PGP Steering Committee Meeting  
October 6, 2020 2:00pm  
ZOOM

Minutes

**Vermont Sidewalk Expansion Plans - (Part of the 17<sup>th</sup> Street Module)**

# Potrero Gateway Park

Public Works' Option 1 sidewalk plan

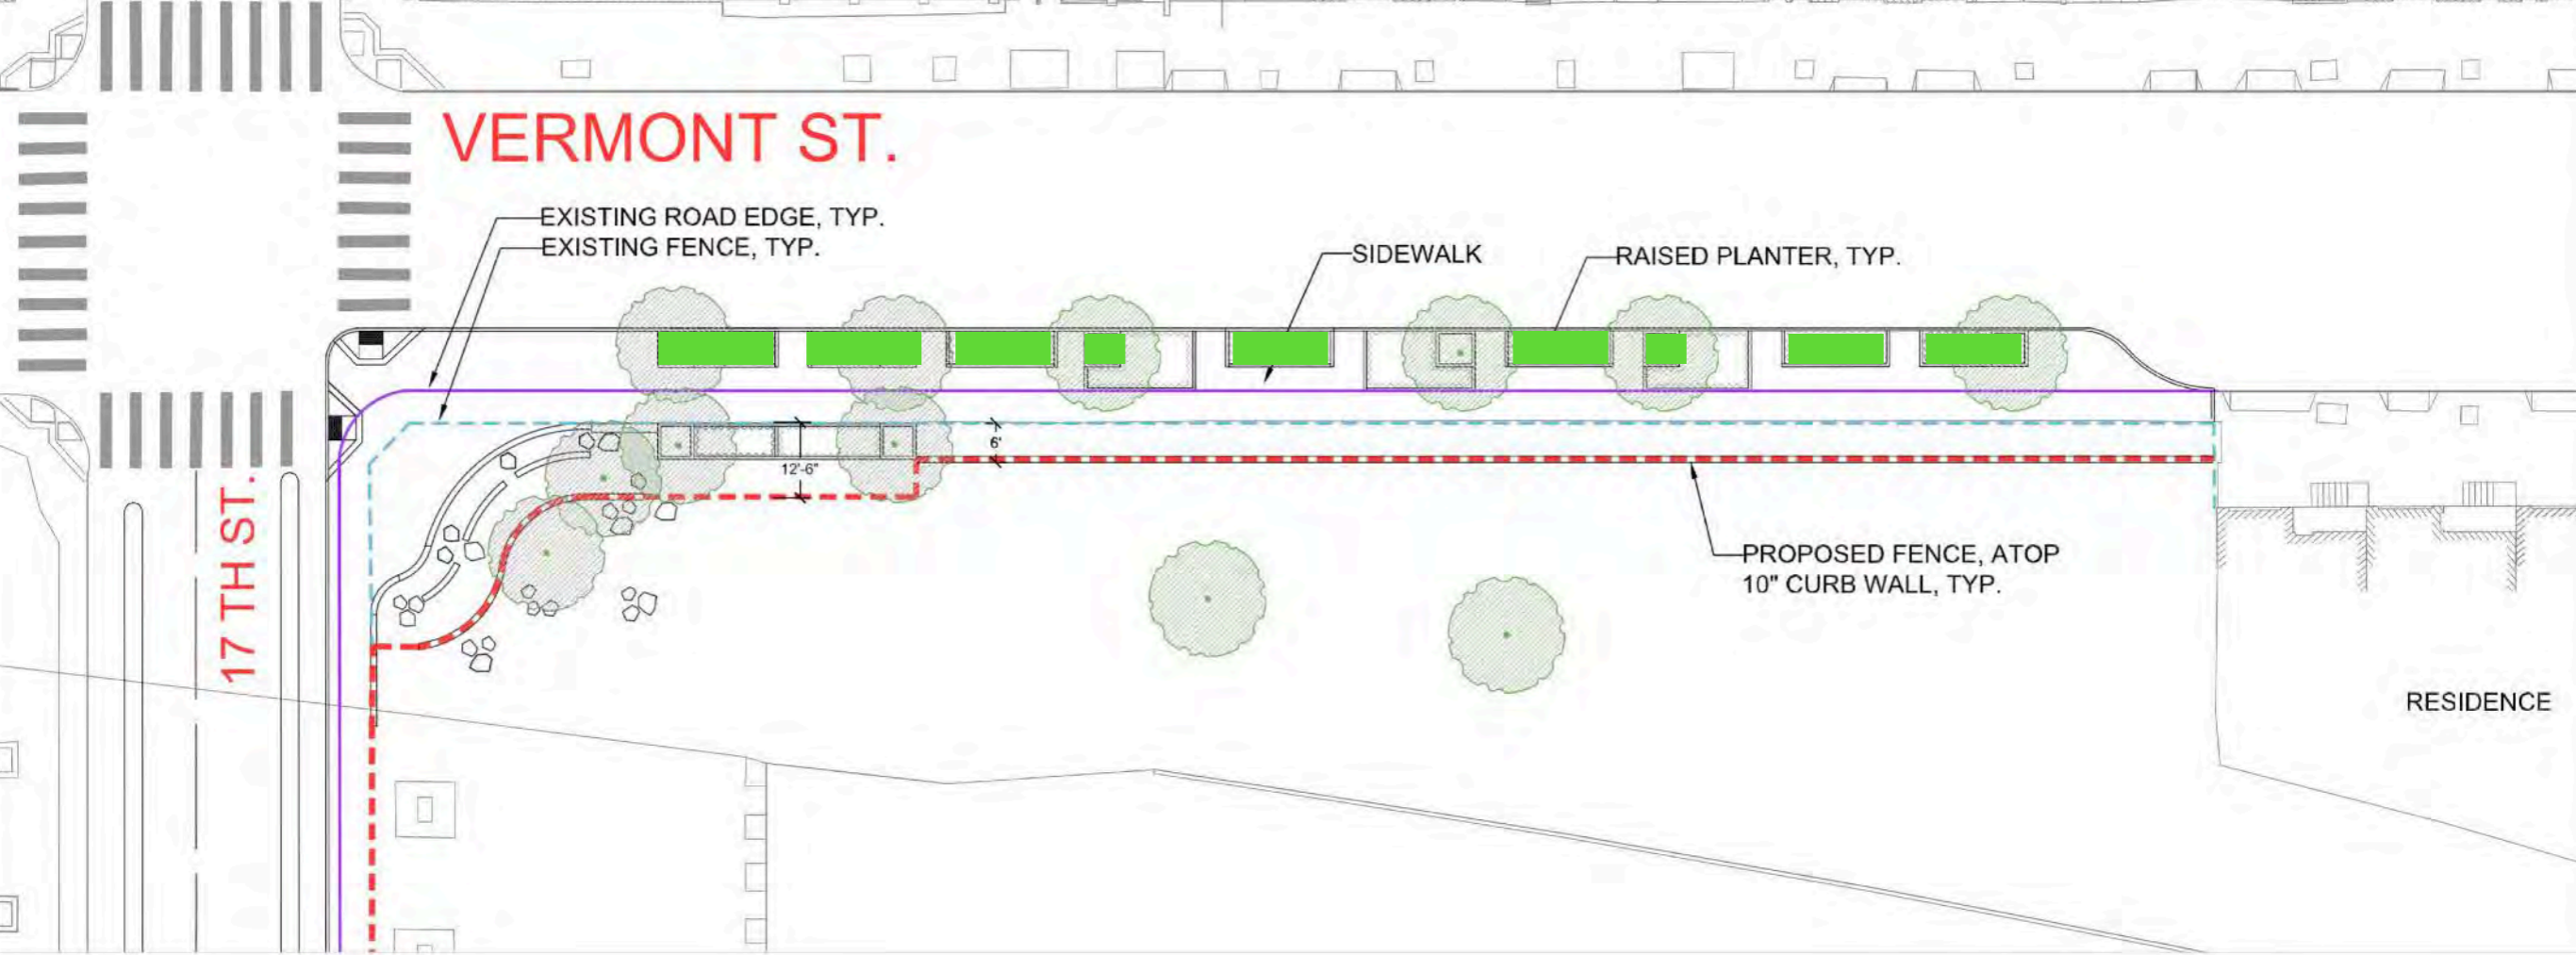
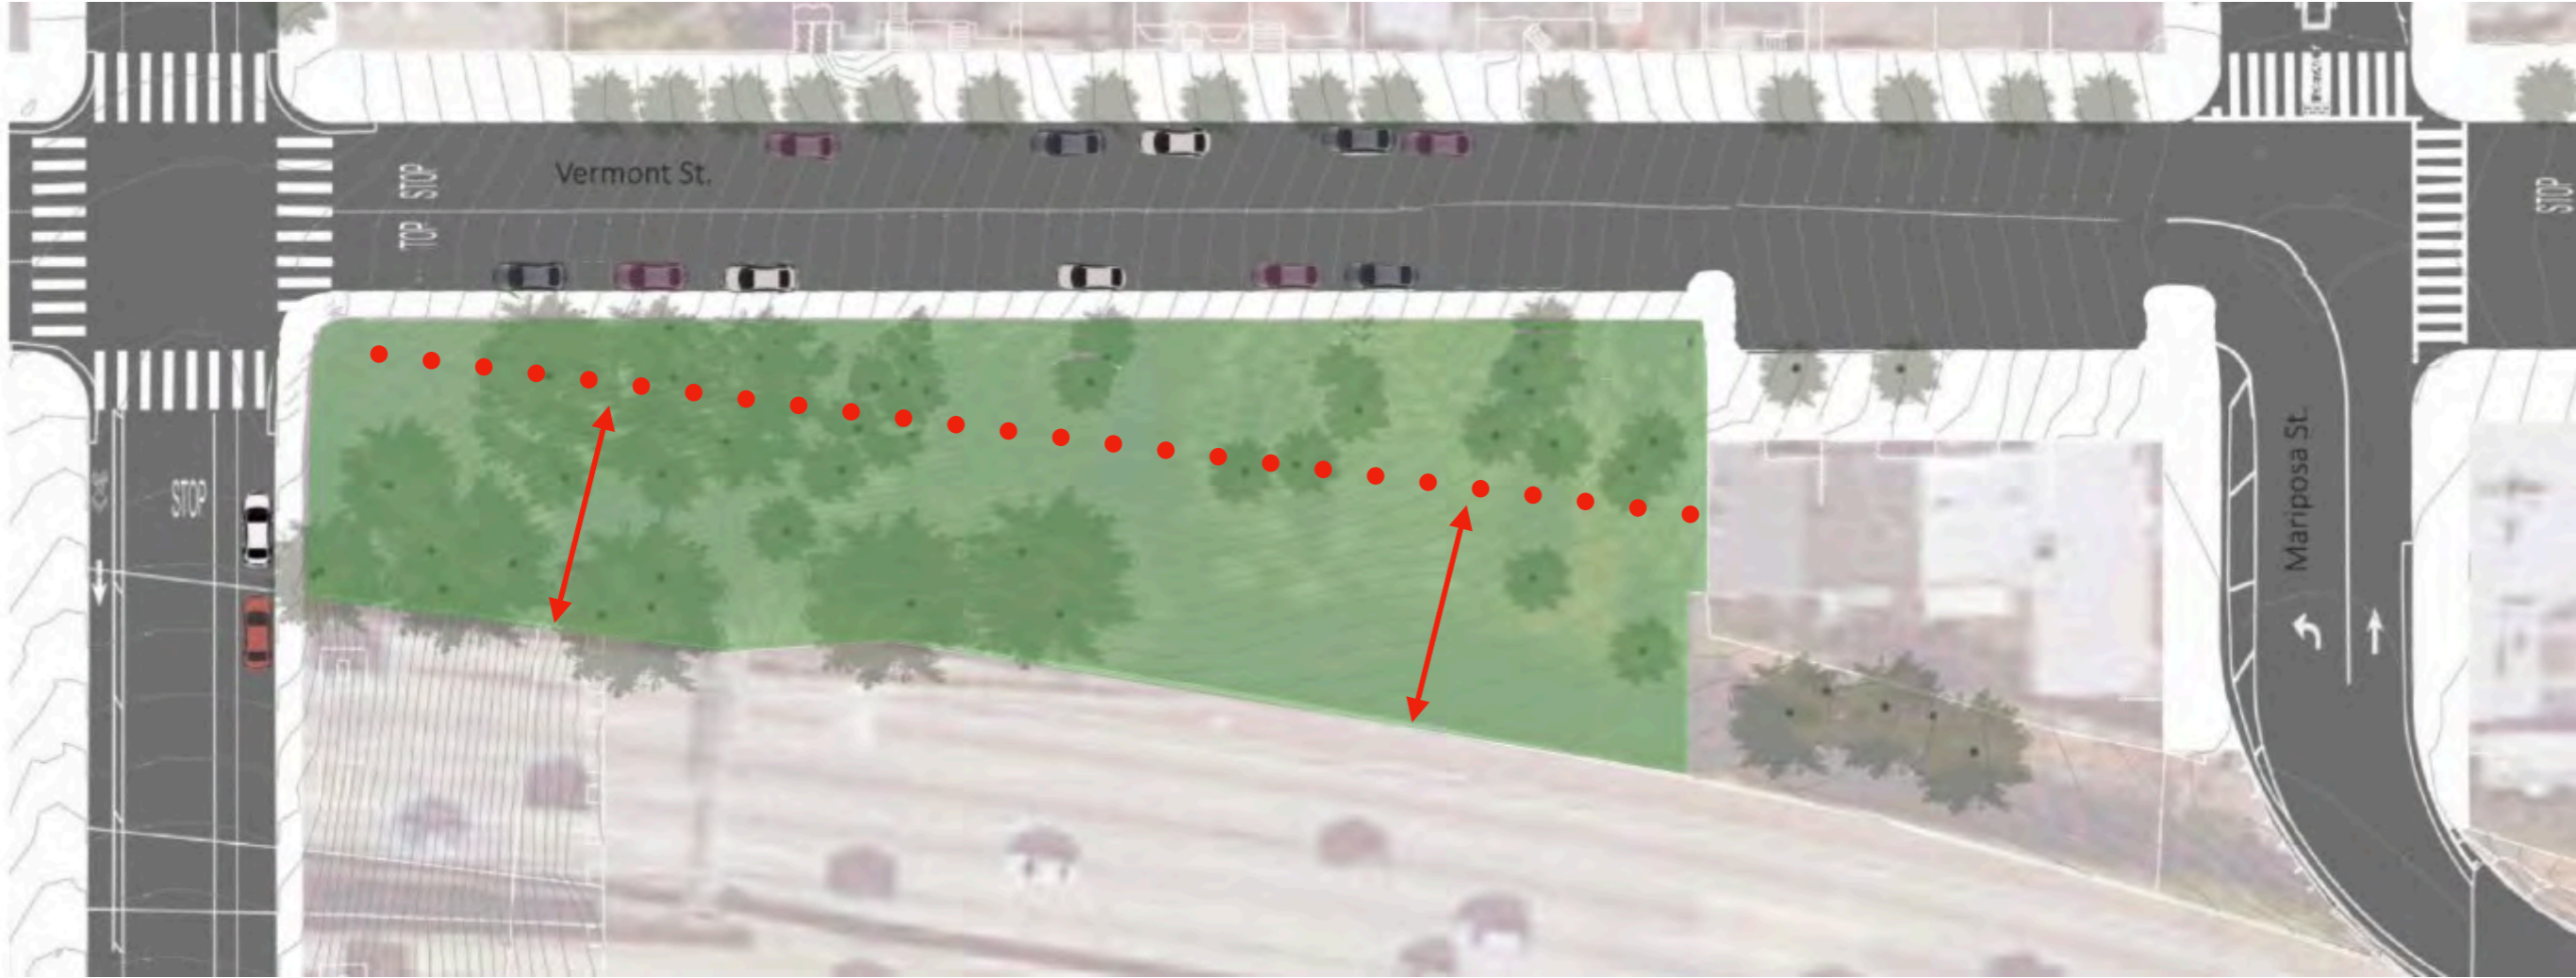
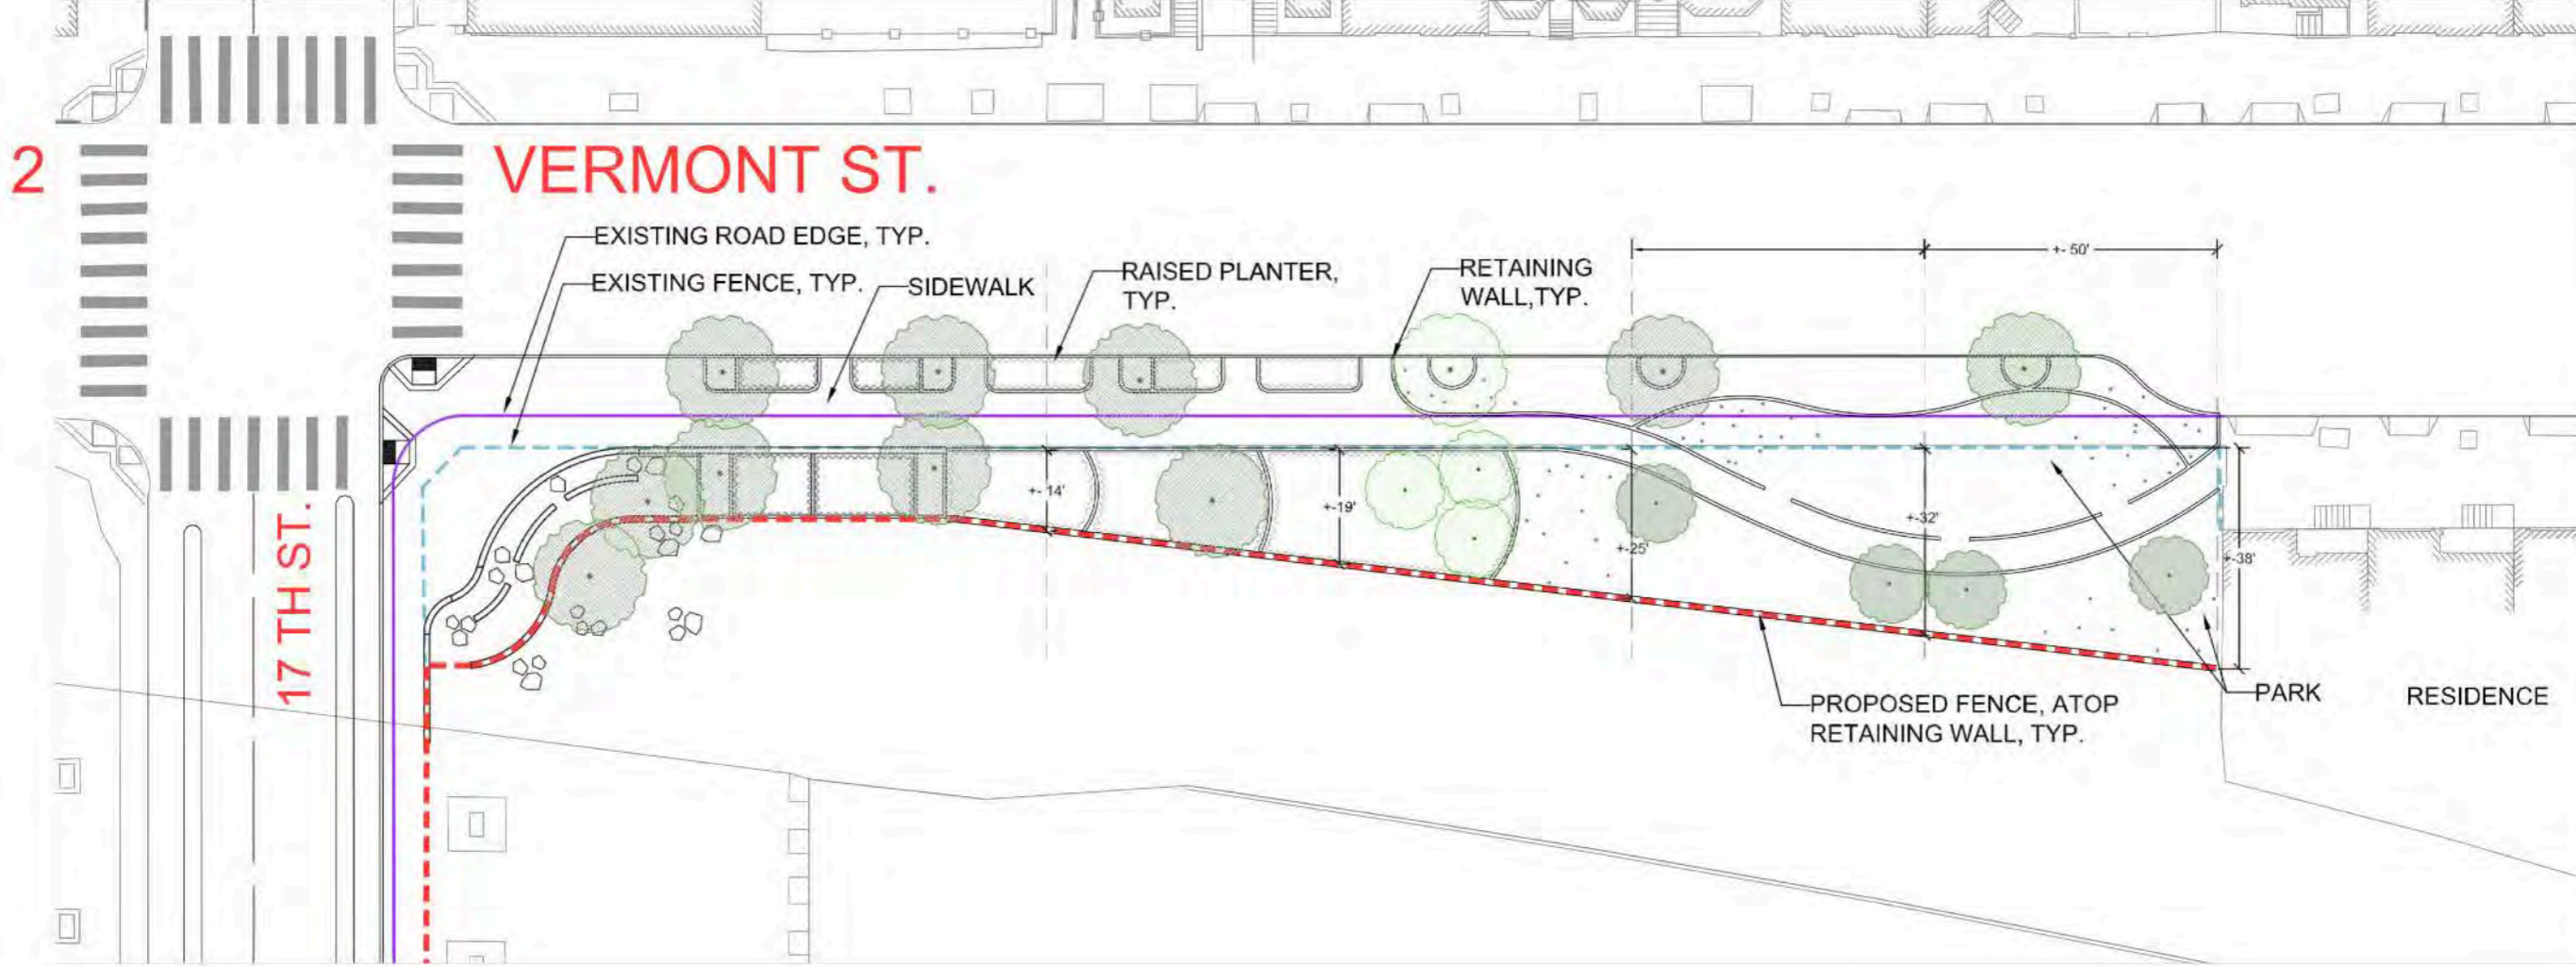
The simple plan creates a very linear path, made worse by the somewhat steep hill.

In the end, it provides little new greenspace.
